Further Information request – 35 Kaitawa Street

| Subject | Further Information Request – Resource Consent Application – 35 Kaitawa Crescent (190125) |

35 Kaitawa Crescent(Update): Water Storage and Hydraulic Neutrality

Figure 1: Proposed subdivision

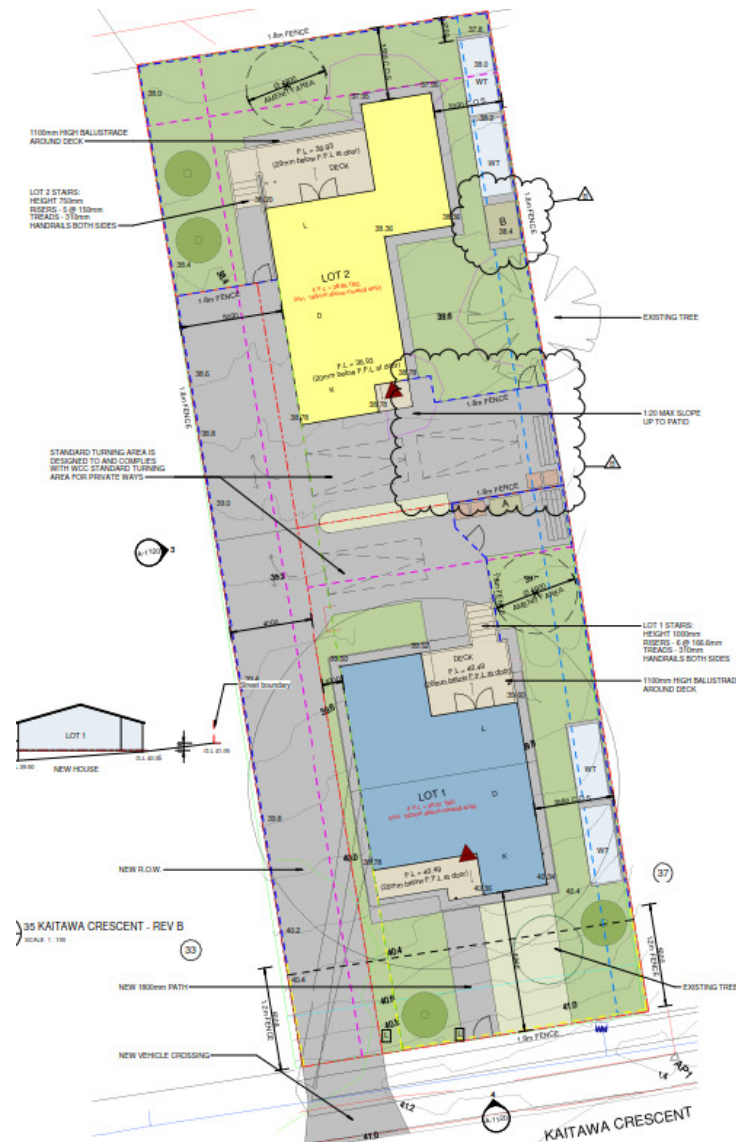
Supply a traffic safety assessment by a suitably qualified person assessing the relevant safety and transport policies and objectives of the Proposed District Plan relating to the non-compliance. Provide an amended Assessment of Environmental Effect assessing all of the relevant objectives and policies relating to the shortfall of parking spaces.

The proposed sub-division is shown in Figure 1 below and in summary is to:

- Subdivide one existing section (with an existing dwelling which is to be removed) into two new sections;
- The front section will have a 72m² floor area unit with two bedrooms;

- The back section will have a 139m² total floor area (79m² ground floor area) unit with four bedrooms; and
- Provide a shared driveway with one off-street parking for the front section and a tandem off-street parking for the rear-section.

Overall the proposed sub-division is consistent with the Proposed District Plan policies and objectives relating to parking despite the non-conformance in the number of parks for the front unit and the rear units parks not being designed in accordance with AS/NZS 2890.1:2004.

BUILDING CONSENT
TITLE
SITE PLAN - PROPOSED

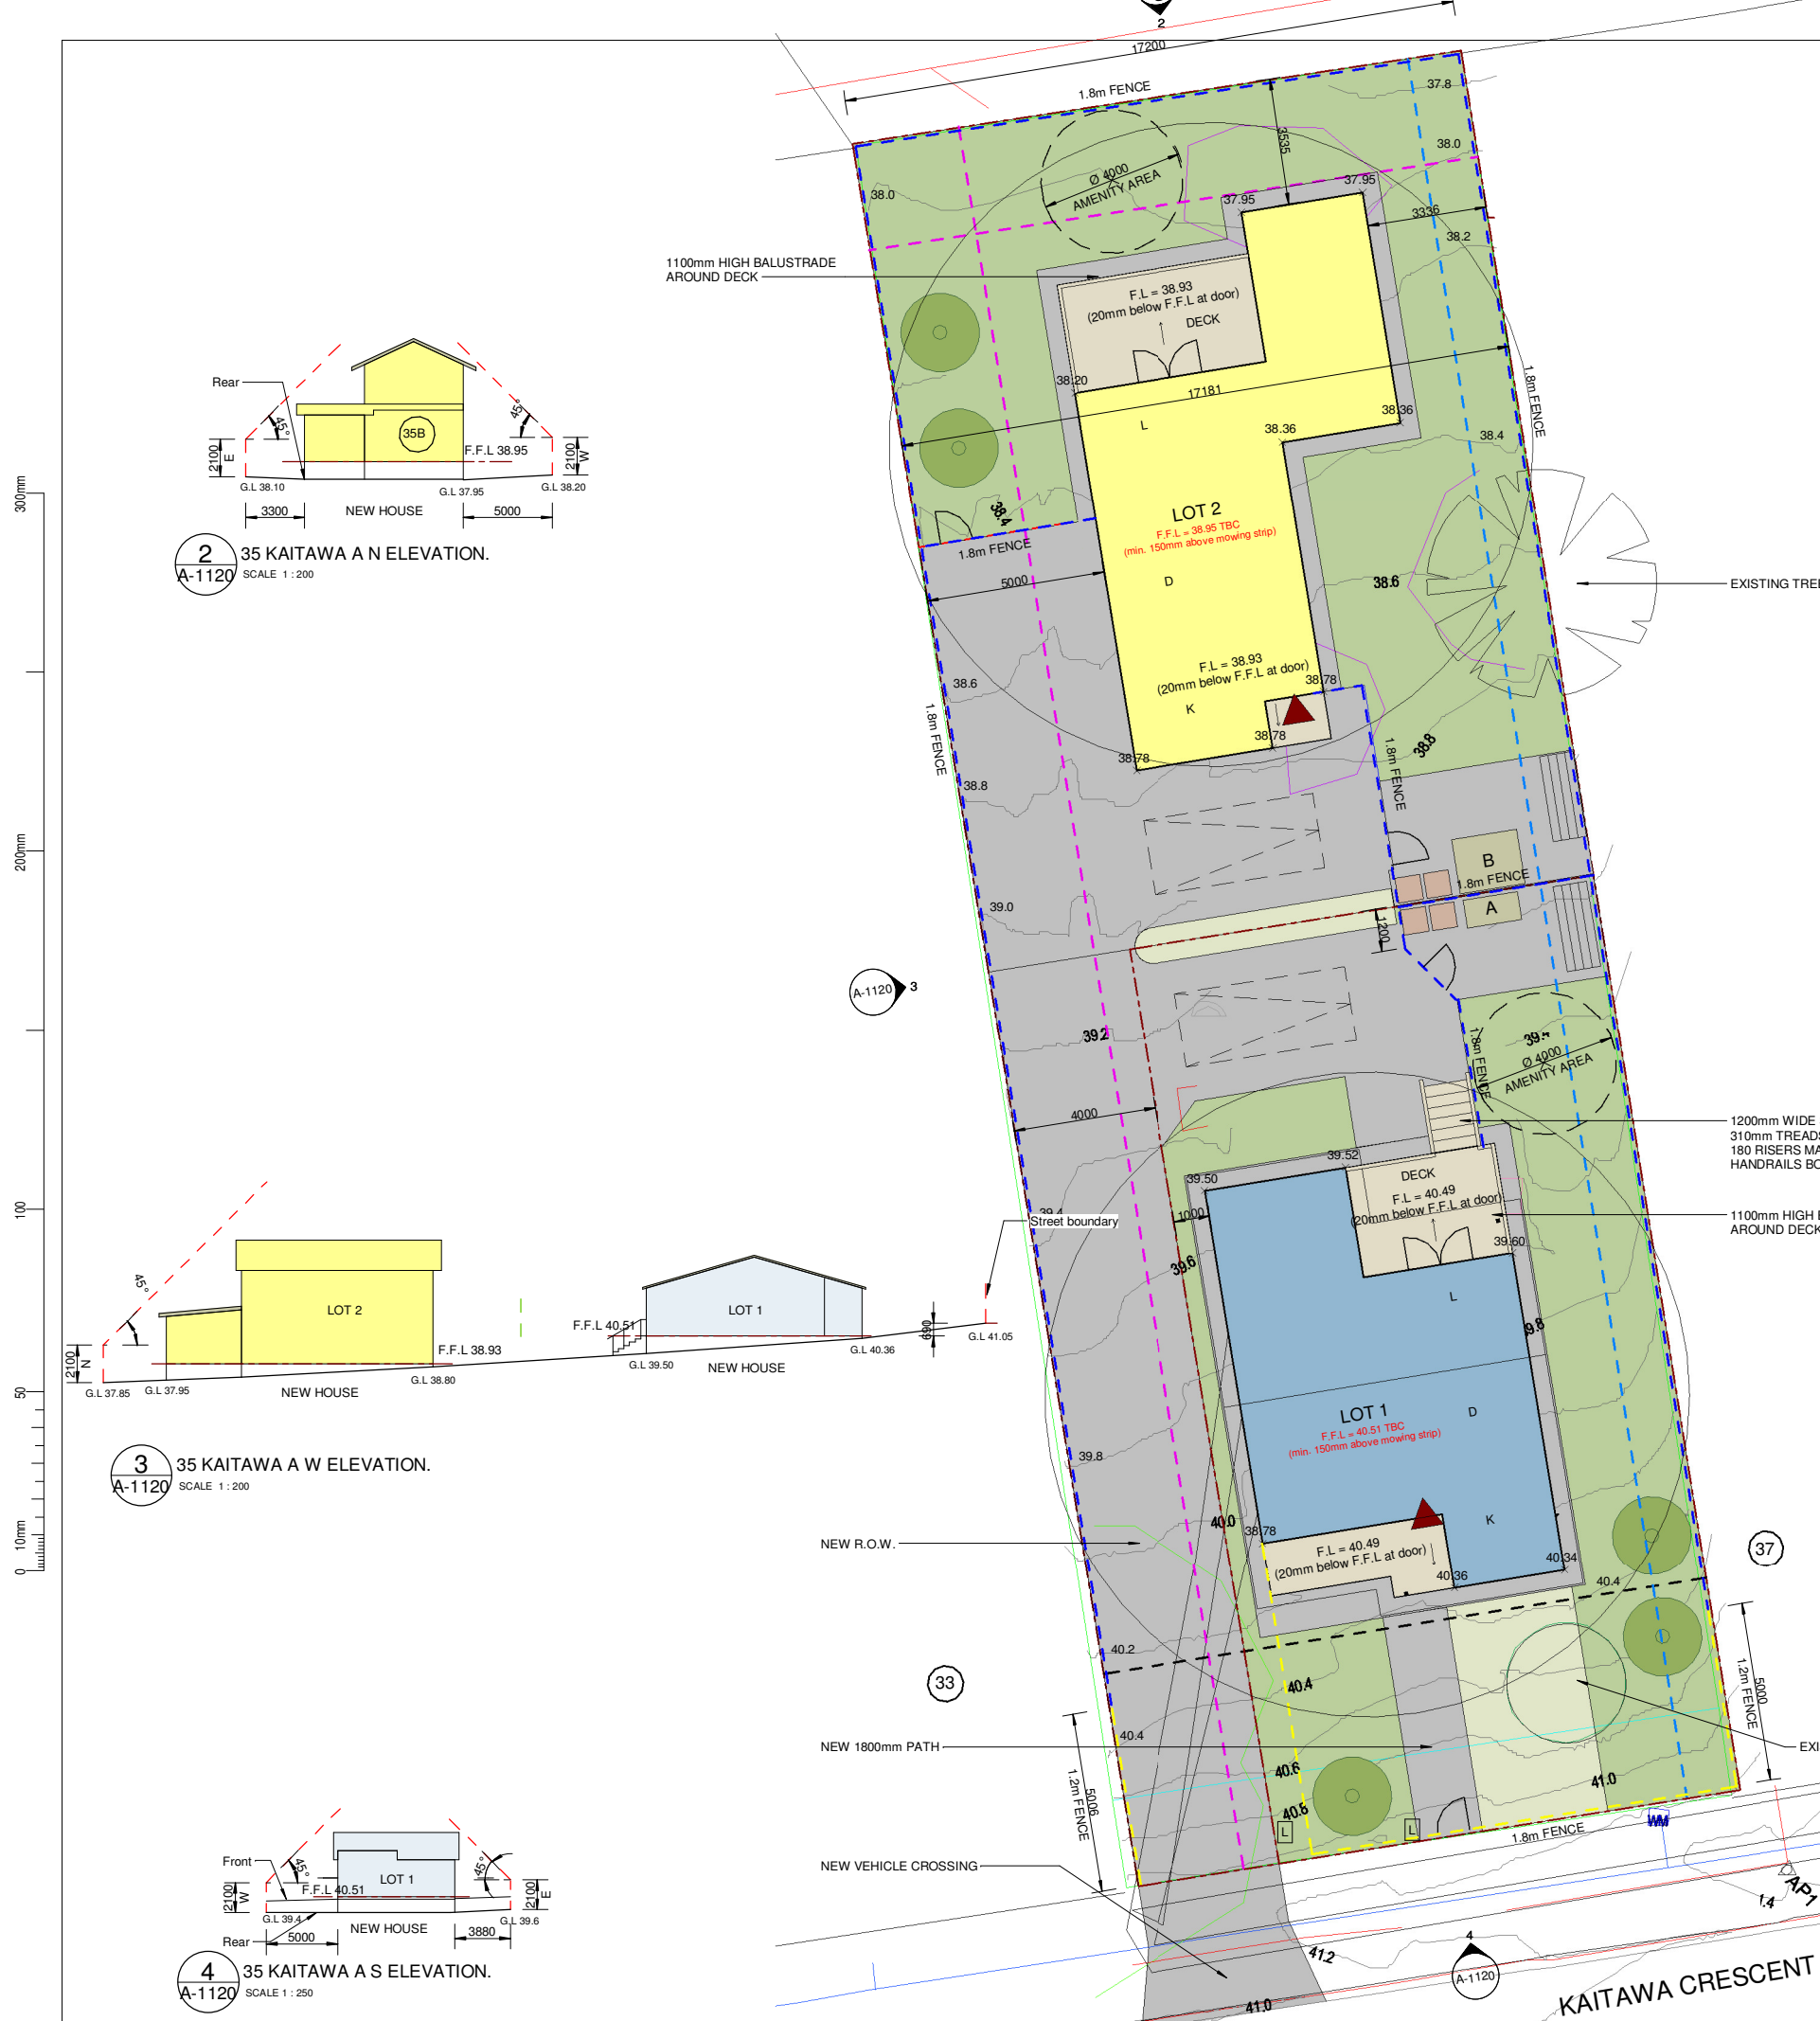
1. **An amended plan with height in relation to boundary shown for:**
 - a. **Water tanks and accessory buildings**
 - b. **Location of the water tanks in relation to the boundaries.**

3. **Amend the site plan showing the shape factor for both proposed lots.**

The water tanks and sheds will be a maximum of 2.0m in height and will therefore comply with the 2.1m plus 45° recession plane requirements. As stated in the application and shown on the plans the water tanks will be located on the boundaries with a 1m yard encroachment which has been applied for as part of the application.

Please see the attached plan – this does not comply as the original site is not 18m wide.

Minor changes to the paving areas are present in Figure 1 and amended stormwater calculations are appended in Appendix A.
